### ADDENDUM NO. 5

DATE: August 15, 2018

PROJECT: ITB 0318-2360 FIRST STEP SHELTER BUILDING

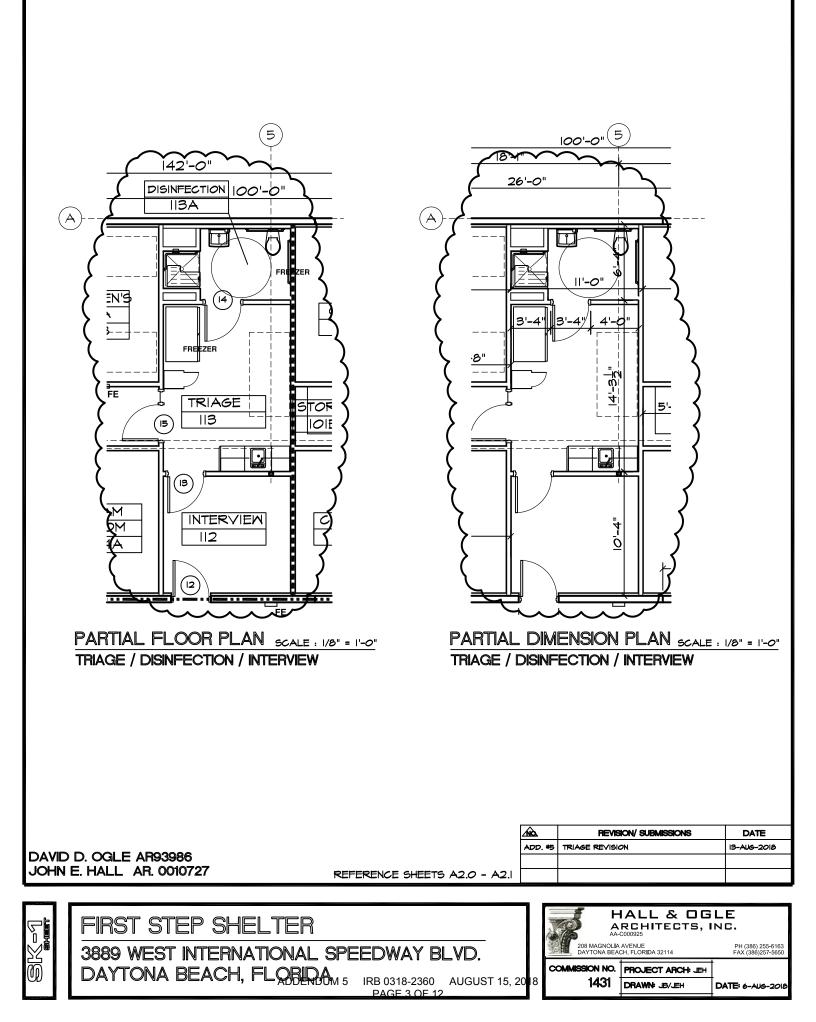
ADD.5.01 <u>Sheet A2.0 - A2.1 - Floor Plan and Dimension Plans:</u> At the area between the Health Ward and the Administration Areas, revise rooms 112, 113 and 113A as shown on attached sketch SK-1. Revise door 13 from being an exterior door to be an interior door similar to door 11. Room finishes at 113A to match Toilet Rooms. ADD.5.02 Sheets S2.0, S2.1 and S2.2 - Foundation Plan, Slab Plan and Low Roof Framing Plan:

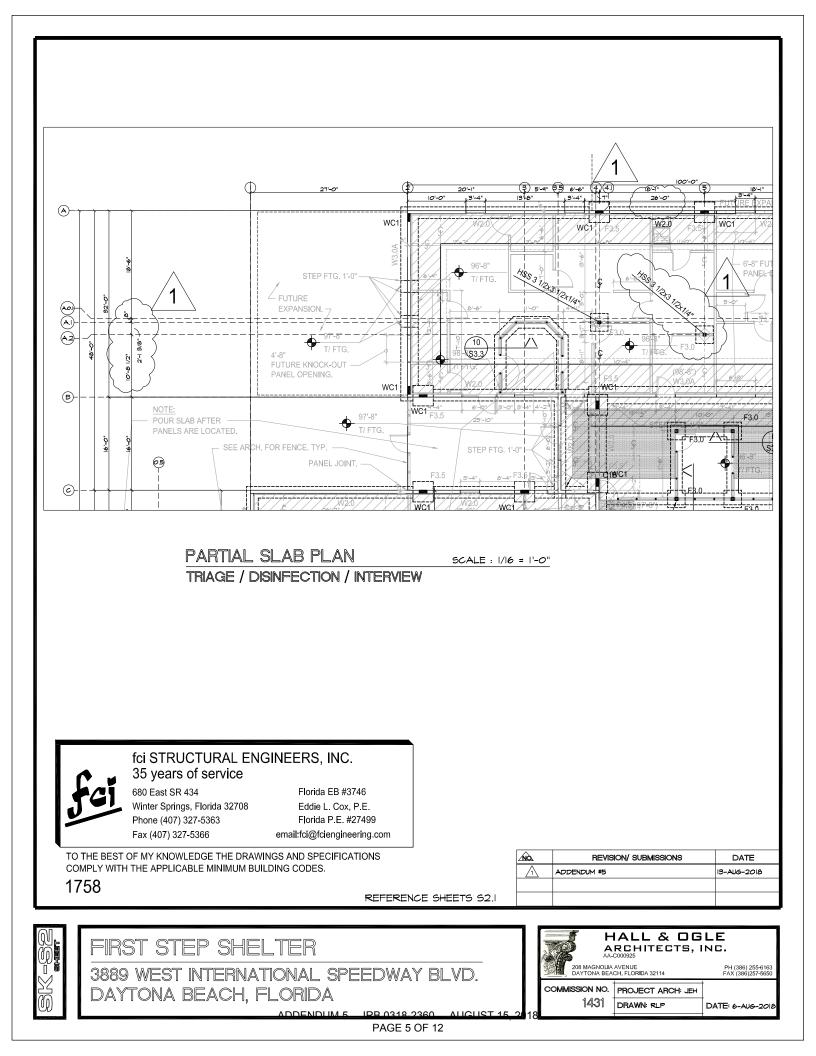
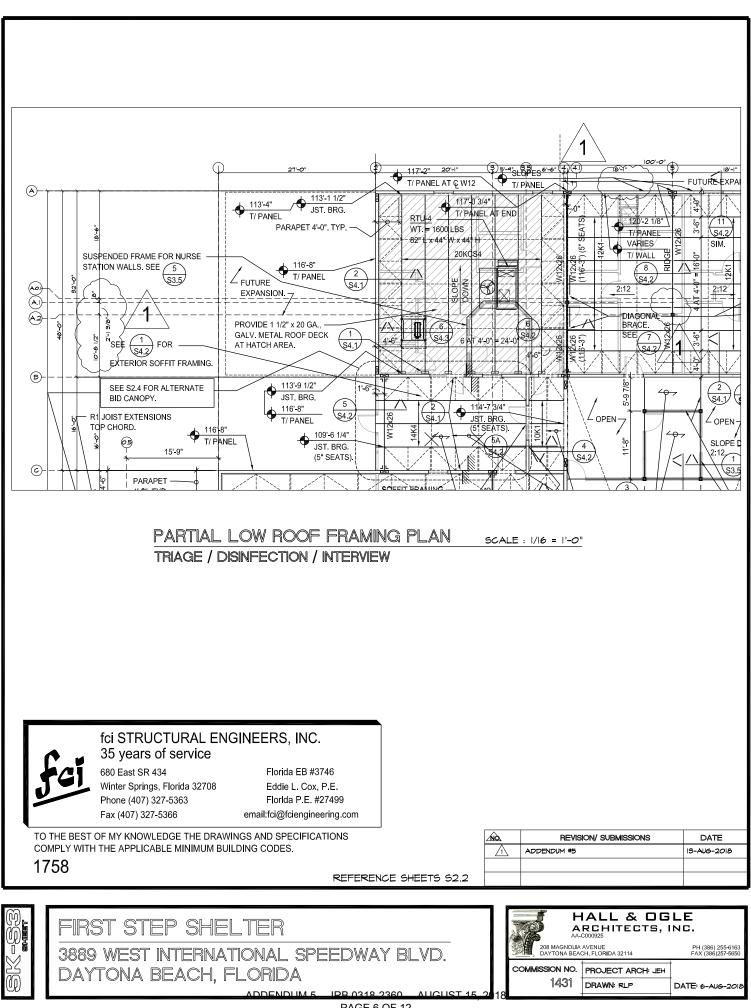
At grid line 5, relocate steel column as shown on attached sketches. Delete exterior door opening between grid lines 4.1 and 5.

Note: Steel beams at ridge line stay same size, the lengths revise.

**REFERENCE SHEET M-601**

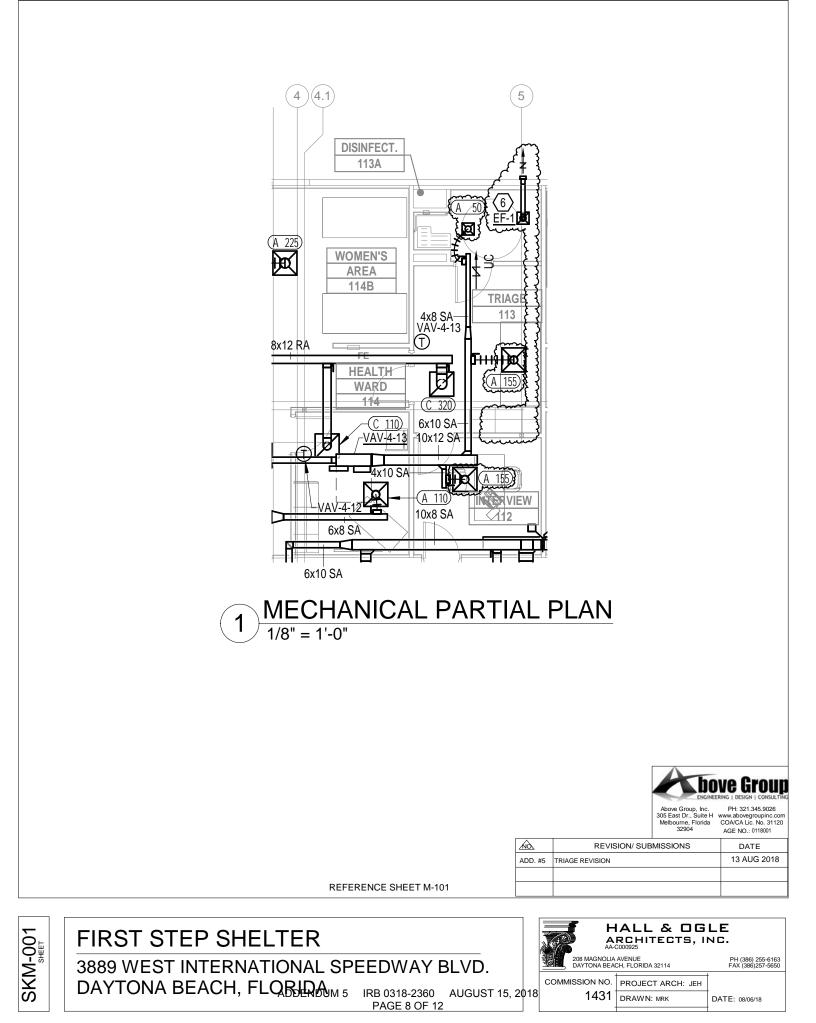
ADD.5.03 <u>Sheets M-101 and M-601- Mech. Floor Plan and Mech. Schedules:</u> At rooms 112, 113 and 113A revise the supply and exhaust air as shown on attached sketches. Revise exhaust fan as shown on sketches.

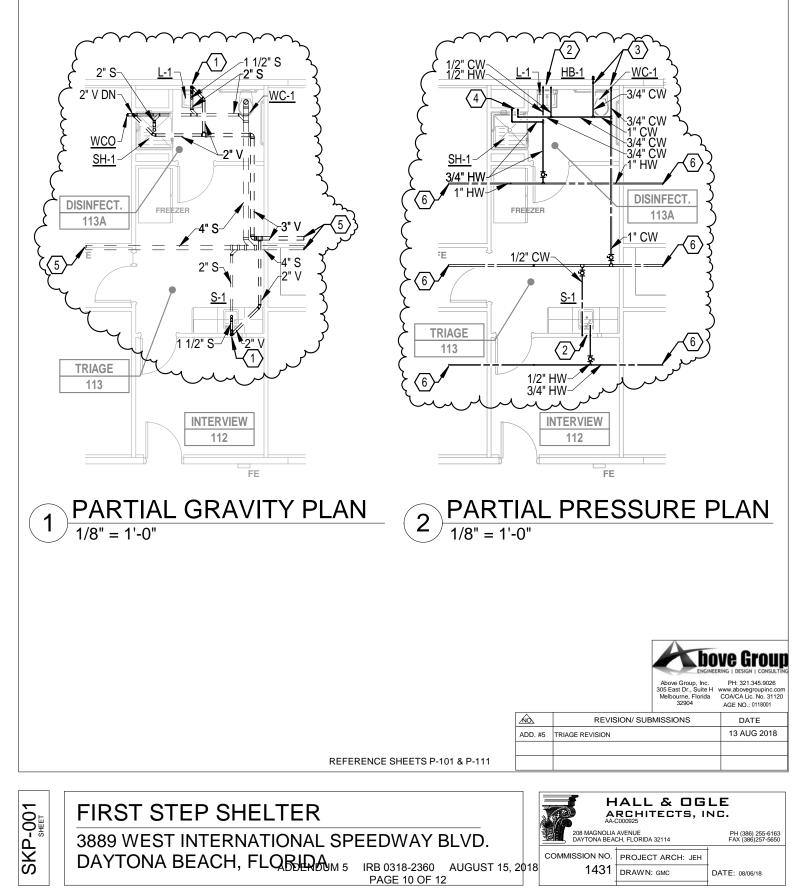
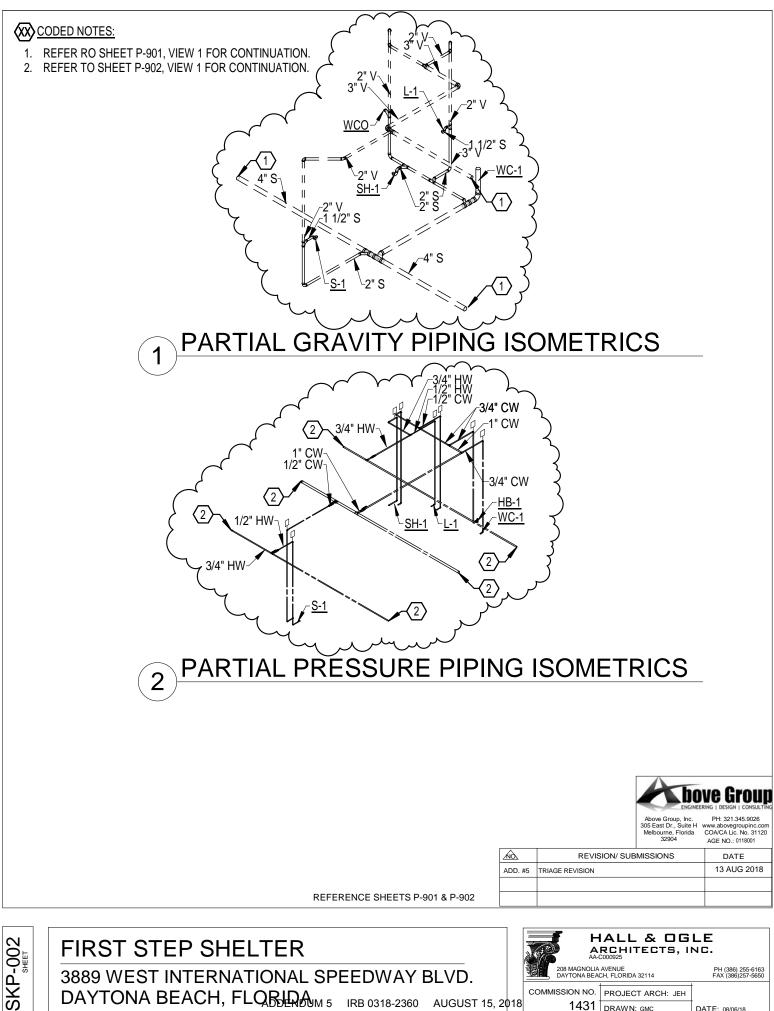
ADD.5.04 <u>Sheets P-101, P-111. P-901 and P-902 - Gravity and Pressure</u> <u>Piping Plans and Isometrics:</u>

At rooms 112, 113 and 113A revise plumbing layouts and piping as shown on attached sketches.

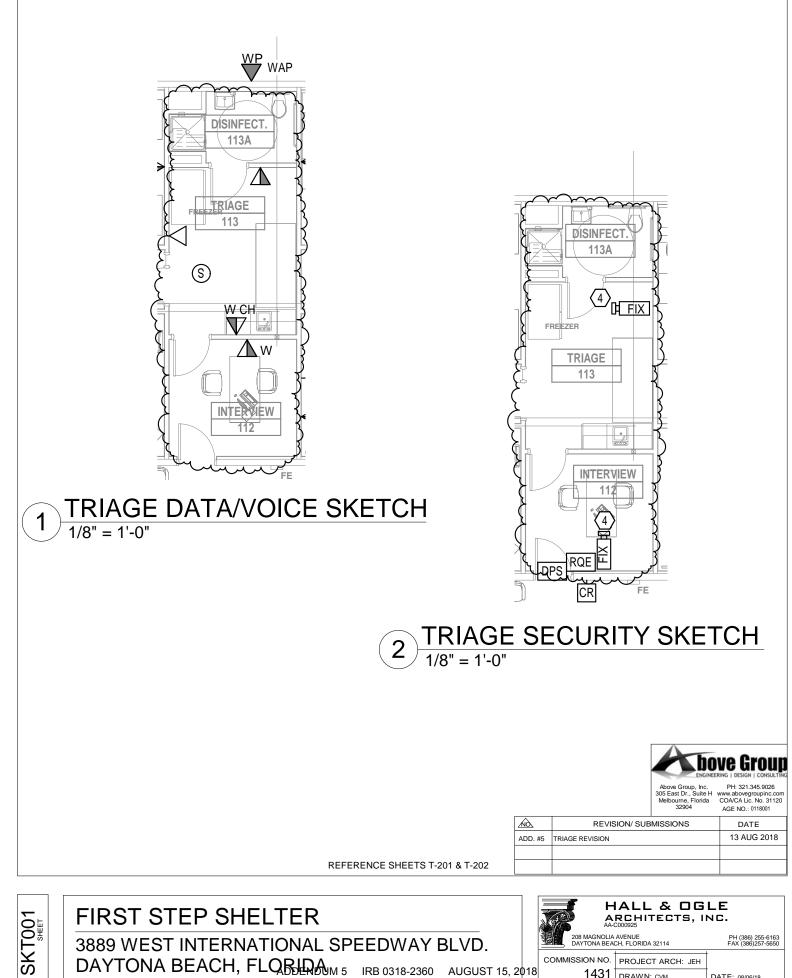
ADD.5.05 <u>Sheets E-101 and E-102 - Power and Lighting Plans:</u> At rooms 112, 113 and 113A revise the power and lighting as shown on attached sketches.

ADD.5.07 <u>Sheets E-101 and E-102 - Power and Lighting Plans:</u> At rooms 112, 113 and 113A revise the voice, data and security as shown on attached sketches.
